Amendment of the Market Ancillary Service Specification (MASS) – Very Fast FCAS

Draft Report and Determination

Notice of Second Stage Consultation – Amendment of the Market Ancillary Service Specification (MASS) – Very Fast FCAS

Figure 1 Comparison of Very Fast FCAS response times and inertia levels on RoCoF in South Australia, Queensland and the mainland NEM in 2022 and 2026

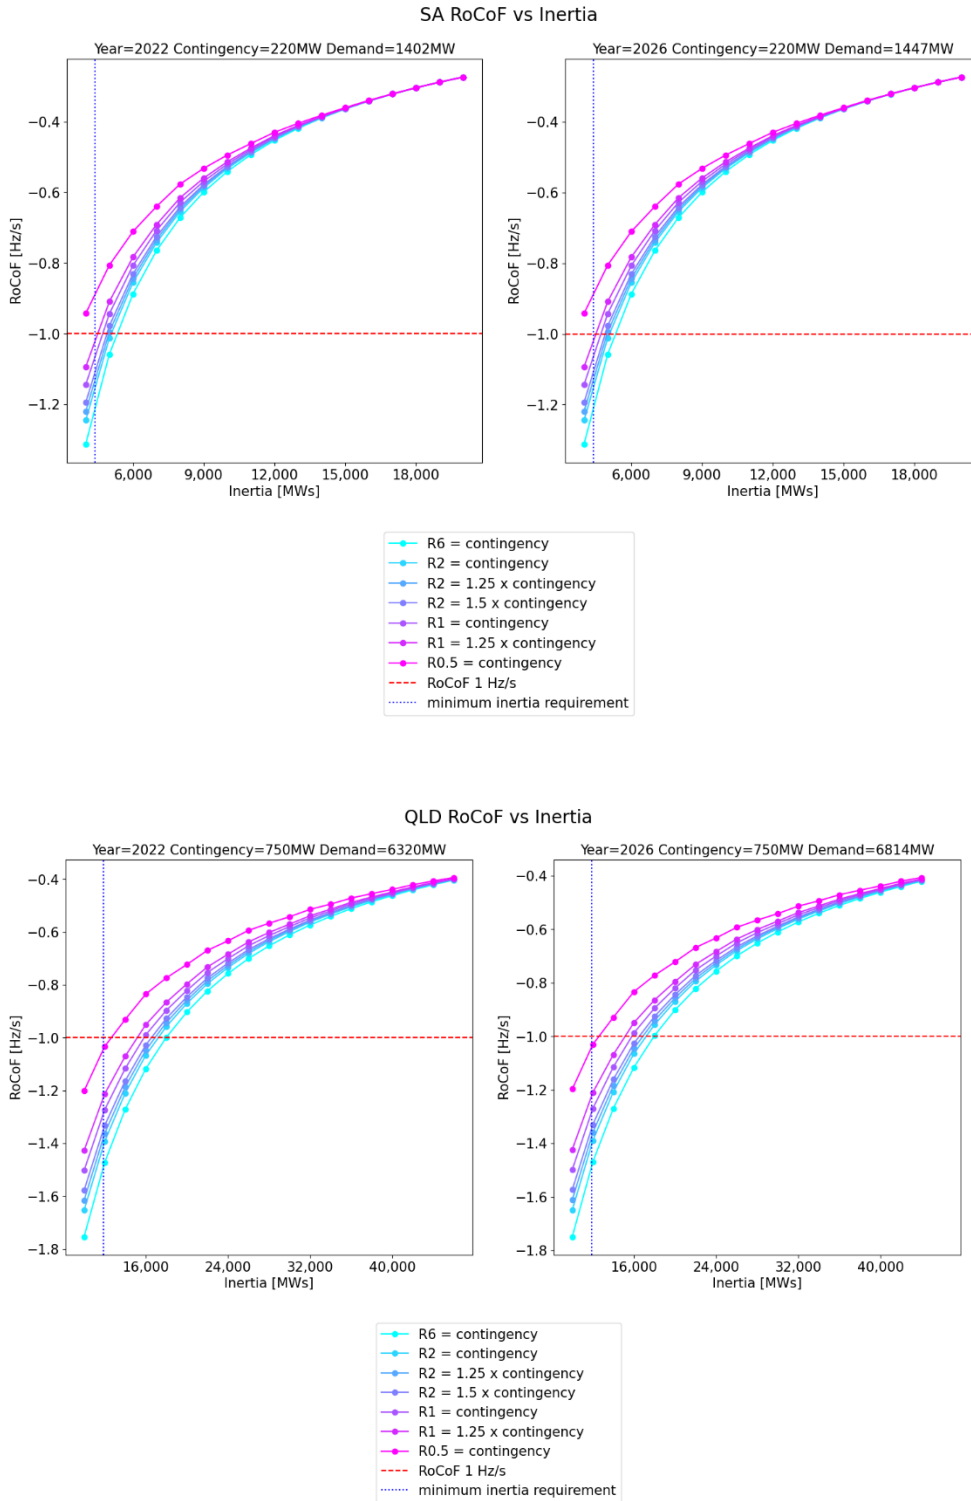
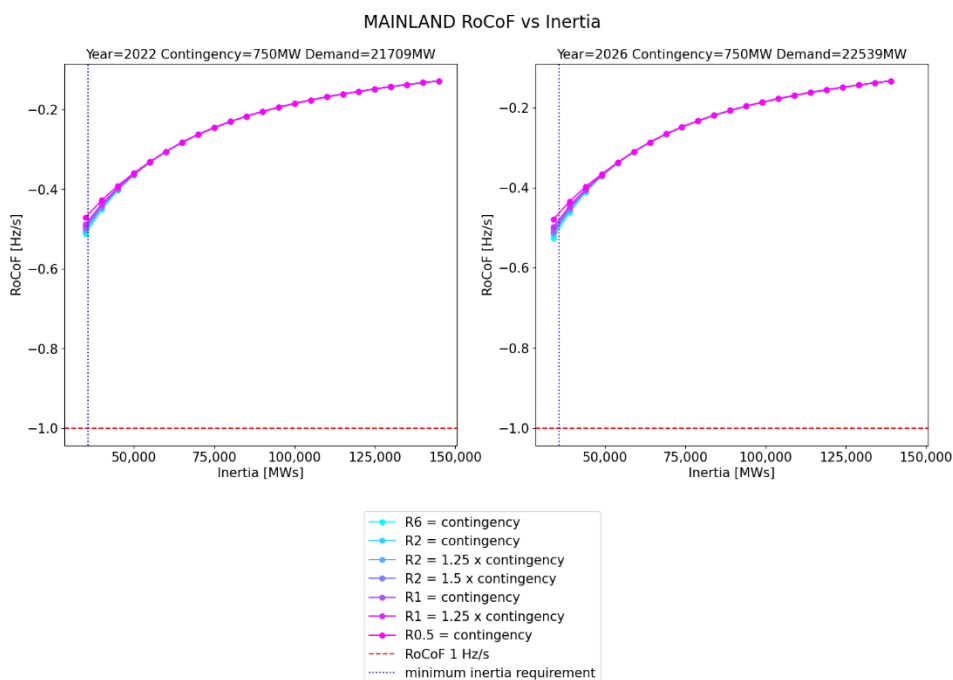
Shell Energy also submitted that the studies completed by AEMO for the Issues Paper should have considered the impact of different response times for Very Fast FCAS on RoCoF and not just the frequency nadir. While AEMO compared the RoCoF observed when varying the response times for Very Fast FCAS in Table 5 of the Issues Paper, the study was based on projected minimum inertia levels for 2022 and 2026 from the Draft 2022 ISP modelling. To address Shell Energy’s suggestion, the same model used to complete the studies shared in the Addendum was updated to compare RoCoF against inertia rather than the frequency nadir against inertia. These results are shown in Figure 1.

AEMO considers that while this additional study shows the effectiveness of a faster response time at maintaining RoCoF closer to 1 Hz/s, it cannot be used in isolation as the basis to determine the appropriate response time for Very Fast FCAS. As shown in the summary in Table 1, a 1-s response time fails to contain RoCoF below 1 Hz/s for SA and QLD, and even a 0.5-s response time was ineffective for QLD. Furthermore, due to the combined minimum inertia requirement for the mainland, the study shows that a 6-s response time would be adequate. While the FOS specifies the containment bands for a credible contingency, a RoCoF standard is yet to be specified and the results of the study cannot be assessed against any particular requirement.

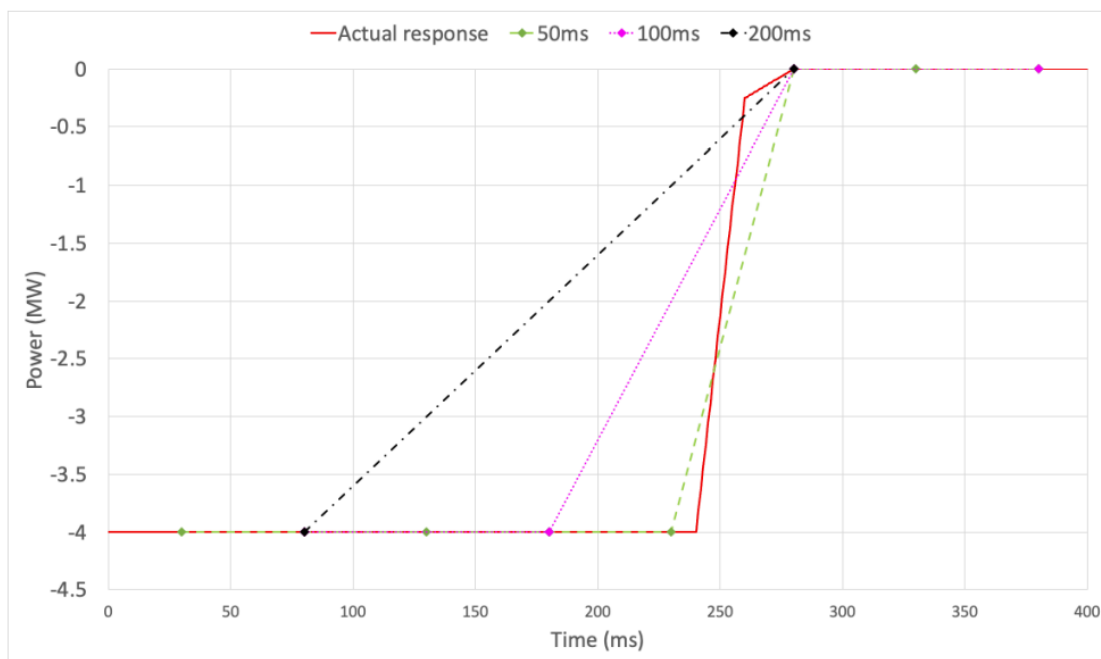
Fig. 3.5 from the UoM study depicts how worst-case underestimation errors might occur based on the timing of samples. Evergen includes here a different sampling timing to indicate how close to worst-case over-estimation might occur for low sample rates:

It seems intuitive that a large over-estimation might occur in the worst case similar to the under-estimation worst case, especially for the 200ms sampling rate case. And yet the bias towards underestimation is apparent in UoM’s results.

Evergen submitted that the UoM study indicated a bias towards underestimation. AEMO notes that measurements captured at a slower sampling rate could fail to capture the stepped response from a switching controller. Subsequently, in the examples considered where the response delay is 0 ms, a linear approximation of the change in active power results in an underestimation of the area of the curve for slower sampling rates and negative values for the assessment error. The integrity of the applied methodology i.e. the rolling assessment window is demonstrated in Figure 3.9 and Figure 3.10 of the UoM report, which show both over- and under-estimation of the assessment error based on the different switched response profiles and delays considered, and no bias towards under-estimation.

Figure 3.12. Error distribution of lower sampling rates for batteries in the assessment case based on FDT

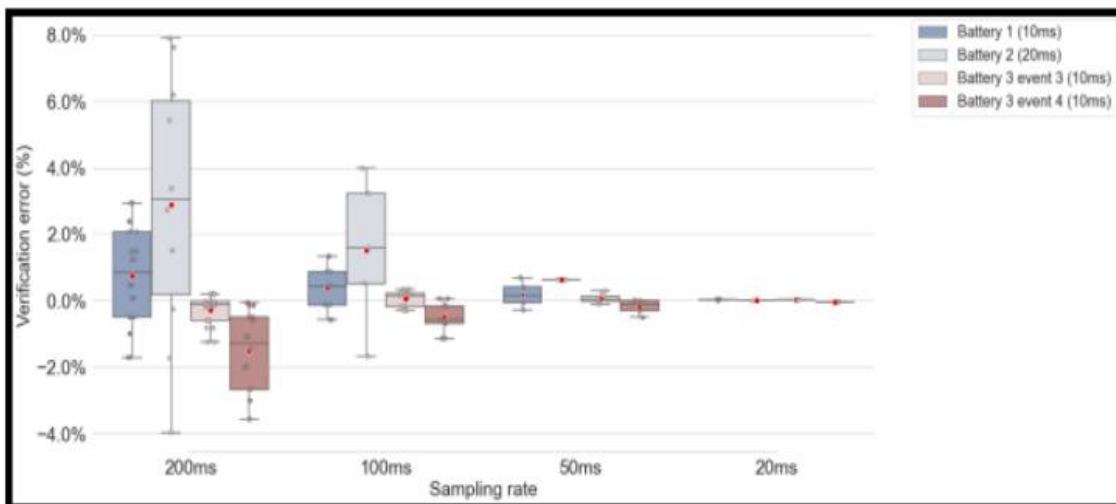
Tesla recommends resolution of frequency measurements at sites allows for aggregated response (>200 sites) with 100ms metering without discount – which is more than sufficient as shown by UoM analysis where verification error trends towards less than 2%, with an outer limit of 4% for single sites.

Figure 2 Impact on frequency nadir in the Mainland due to multiplier effect

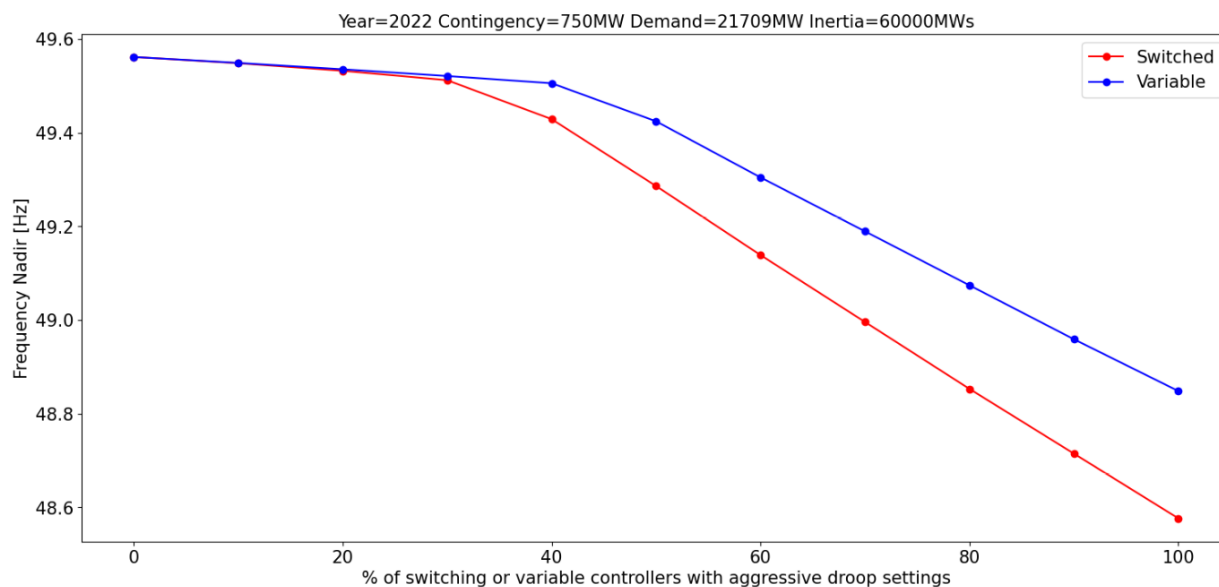
The results of this study are shown in Figure 2, which plots the calculated frequency nadir as the proportion of FCAS provided by FCAS Facilities benefiting from the multiplier effect is increased.

As demonstrated by the results of this study, the impact of the multiplier effect on the frequency nadir is concerning, as quantities greater than 30%-40% mean that the frequency is no longer held within 49.5 Hz. AEMO is already regularly seeing dispatch outcomes with >50% of Contingency FCAS assigned to BESS and switching controllers. This simple model demonstrates how critical it is that the FCAS delivered be equal to the FCAS dispatched by AEMO. Therefore, a cap is required to maintain power system security following a credible contingency event, particularly as it is expected that the number of FCAS Providers using switching controllers and aggressive droop settings will continue to increase. While this study was completed for the mainland only, it is expected that the frequency nadir will be impacted to a greater extent for an island system.

Figure 3 Comparison of total area and time average

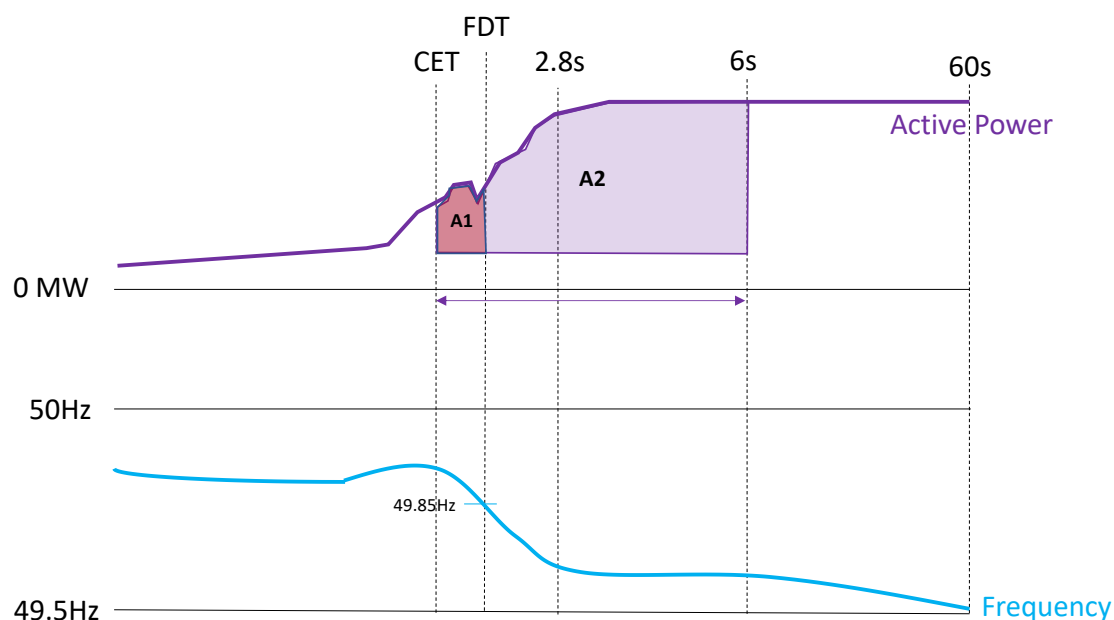
It is possible this concern may be based on a misunderstanding of the FCAS measurement process. FCAS measurement consists of a time average of a relevant period, not a calculation of area. All other things being equal, AEMO cannot identify a realistic scenario where the time average measured from FDT to 6 s after the FDT would result in a lower value than the time

average measured from the Contingency Event Time to 6 s post FDT. An example is illustrated in Figure 3:

While the total area of A1 (CET to FDT period) and A2 (FDT to the 6-s point) is greater than the area between FDT and the 6-s point, the time average of area A2 is greater than the time average of area (A1 + A2). It is the time average that is used in the FCAS calculations, not the area. So the FCAS measured by considering just the period FDT to 6 s later would be greater than if the CET to FDT period was also included.

Figure 4 Example of Adjusted area

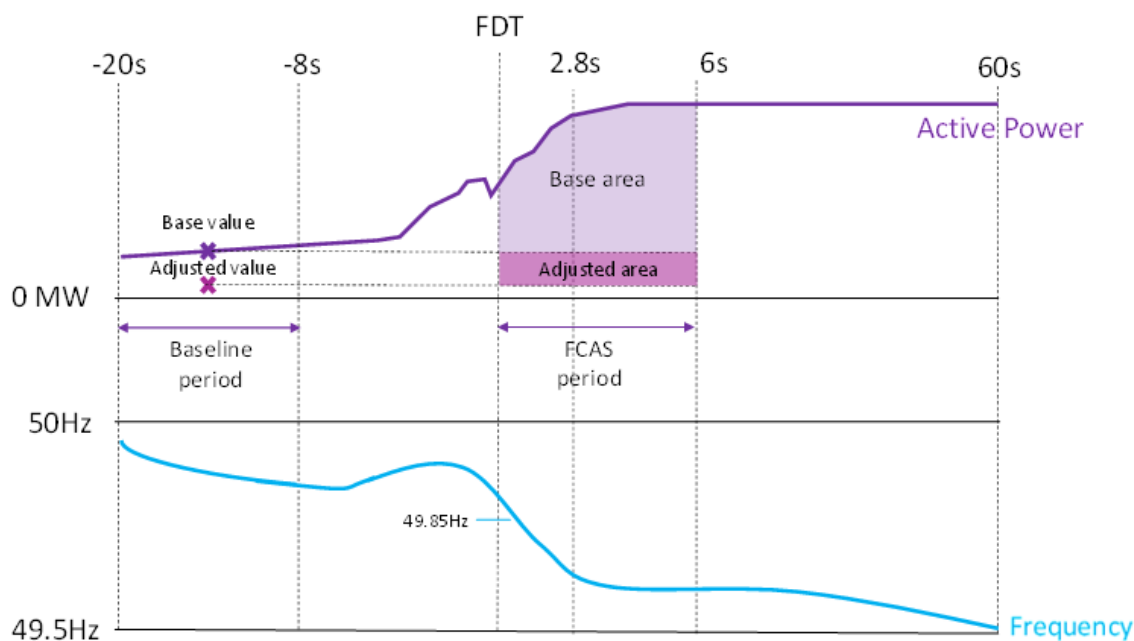
Below is an example of how this would apply. Figure 4 shows the kind of frequency disturbance EnergyAustralia highlighted in its submission, where frequency returns close to nominal prior to contingency event.

In evaluating various approaches and suggested methods against a range of hypothetical frequency disturbances, it appears that no single methodology works ideally in every conceivable circumstance. Therefore, AEMO's objective is to employ a robust methodology that works well for a significant majority of events, which is what AEMO has proposed.
